CONTRACT CHANGE ORDER

CCO: 27 Suppl. No. 0 Contract No. 04 – 0120F4 Road SF-80-13.2/13.9 **FED. AID LOC.:**

This change order modifies the bearing blocks and provides a larger and re-located access opening for placing bearing blocks, tendon anchors, and pre-stressing jacks (used during the installation of the continuity tendons from W2 to the OBG) as shown on sheets three (3) through eighteen (18) of this change order.

SAN FRANCISCO OAKLAND BAY BRIDGE
EAST SPAN SEISMIC SAFETY PROJECT
SELF-ANCHORED SUSPENSION BRIDGE
(SUPERSTRUCTURE & TOWER)

GIRDER FRAMING PLAN NO. 1

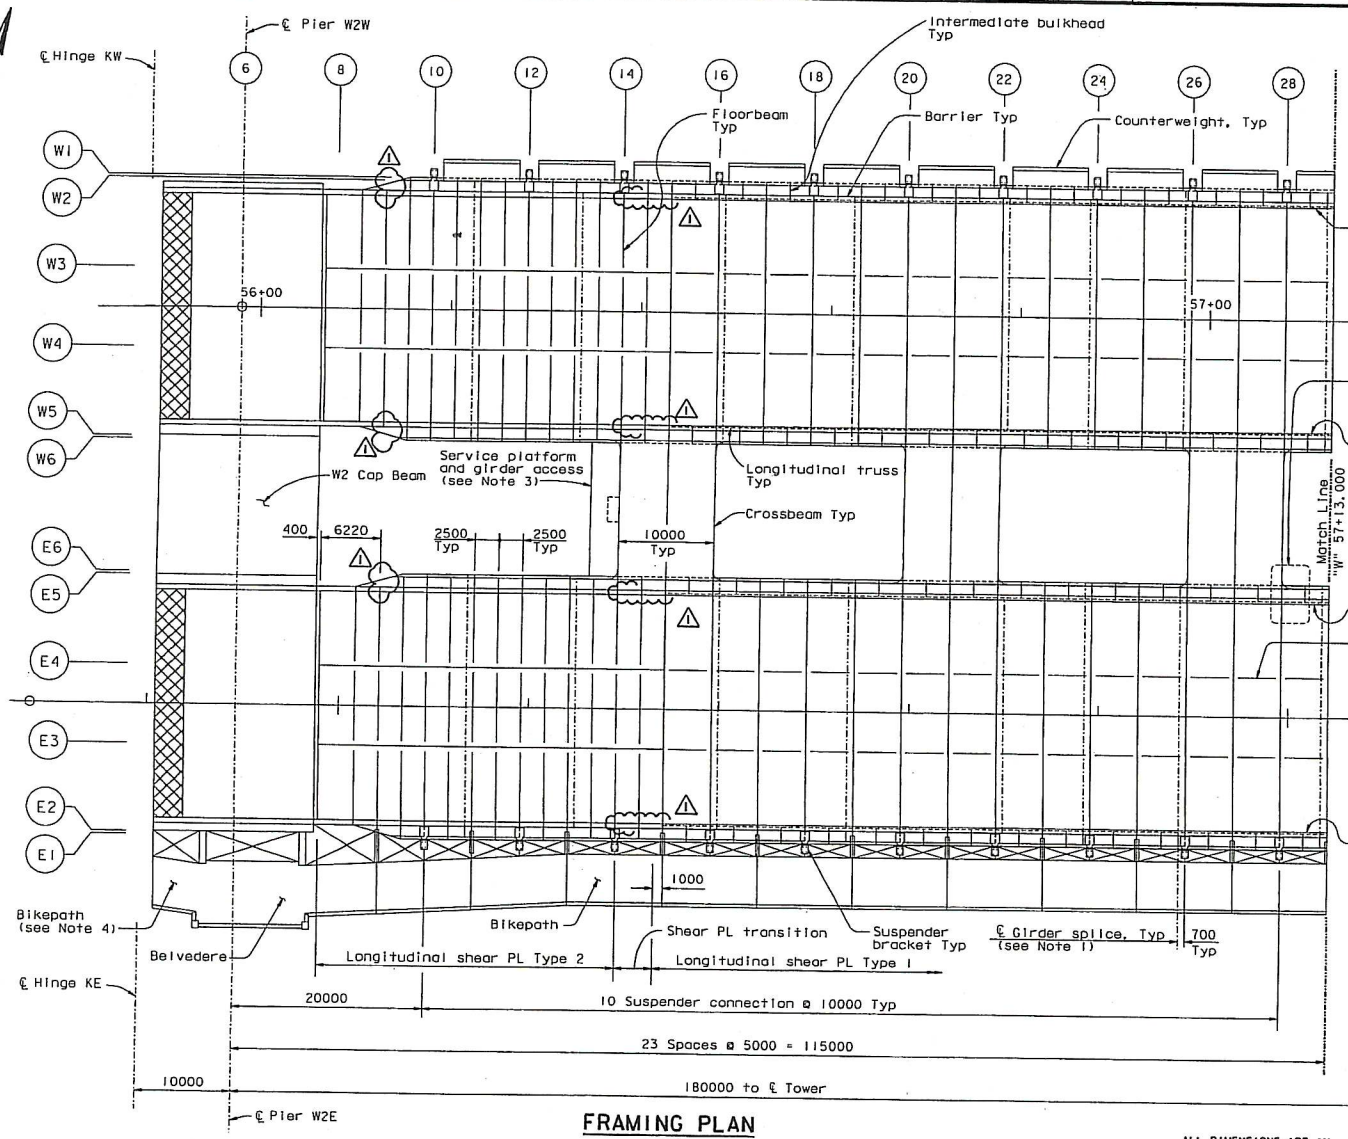
MARK	DATE	DESCRIPTIONS	BY	CH'D	CCO#
1	02/16/07	BULKHEAD AT GIRDER PIER W2	MN	AS	27

DETAIL E (See Note 7) 1
1:10

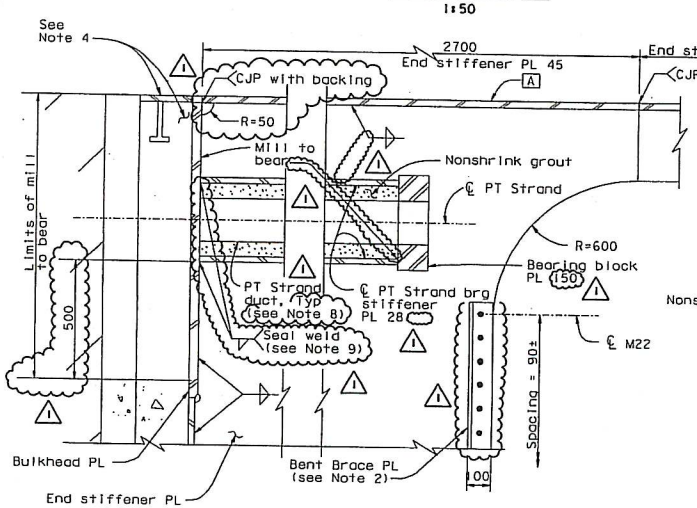
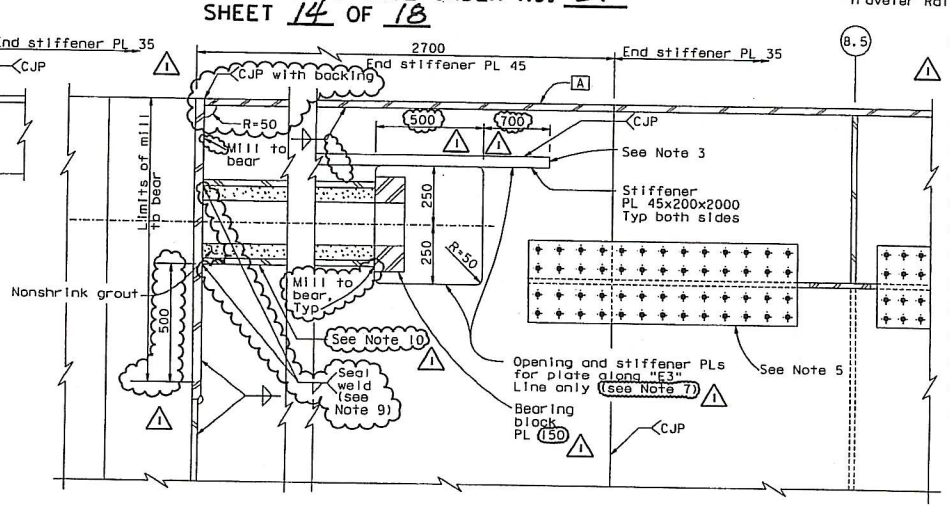
7. For Cutout End Stiffener Plate detail, PT standard bearing stiffener PL dimensions and bearing block types, see "Girder At Pier W2 No. 4A" and "Girder At Pier W2 No. 4B" sheets.

8. The Contractor may substitute the PT duct with a 200 Max diameter standard PT pipe, subject to review and approval of the Engineer. The Contractor may also shop drill a 225 Max diameter hole in the Bulkhead PL to extend the PT pipe into the closure pour side of the Bulkhead PL. The interface between the PT pipe and the Bulkhead PL shall be seal welded all around.
